June 6, 2011 Letter from Dr. Curry

Re: Agenda Items 1 & 2,
Santa Barbara County Planning Commission Meeting June 6, 2011

EVALUATION OF PROPOSED MINING ACTIVITIES IN THE CUYAMA RIVER ALLUVIAL AQUIFER

Plate 1. Antlclinal fold on left bank of Cuyama River across from Diamond Rock Mine parcel.
Oct 11, 2005

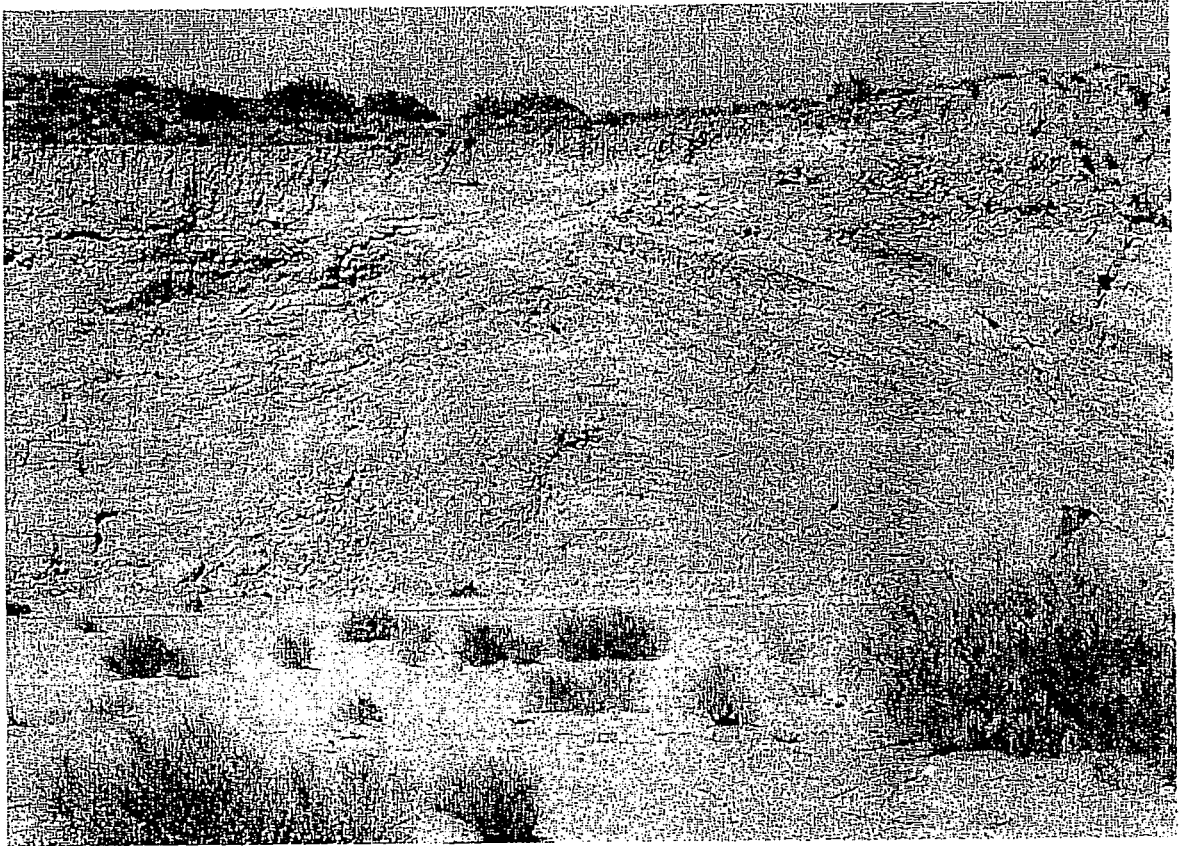
Plate 1 is a photograph of the left (west) bank of the river taken October 11, 2005 when the river first cut deeply into its historic natural banks. This site is upstream from the GPS site and across the channel from the up-stream end of the proposed Diamond Rock site. This site is an old, now abandoned, strath (bedrock) river terrace. About 3 feet of old flood deposits with a well-developed soil lie on top of 10-15 feet of "bedrock" made up of folded poorly-consolidated siltstones. This is contemporary channel-bank erosion that is at least partly the result of channel constriction downstream at the GPS mine. The proposed protective structures for the Diamond Rock mine will exacerbate and expand this bank-cutting.
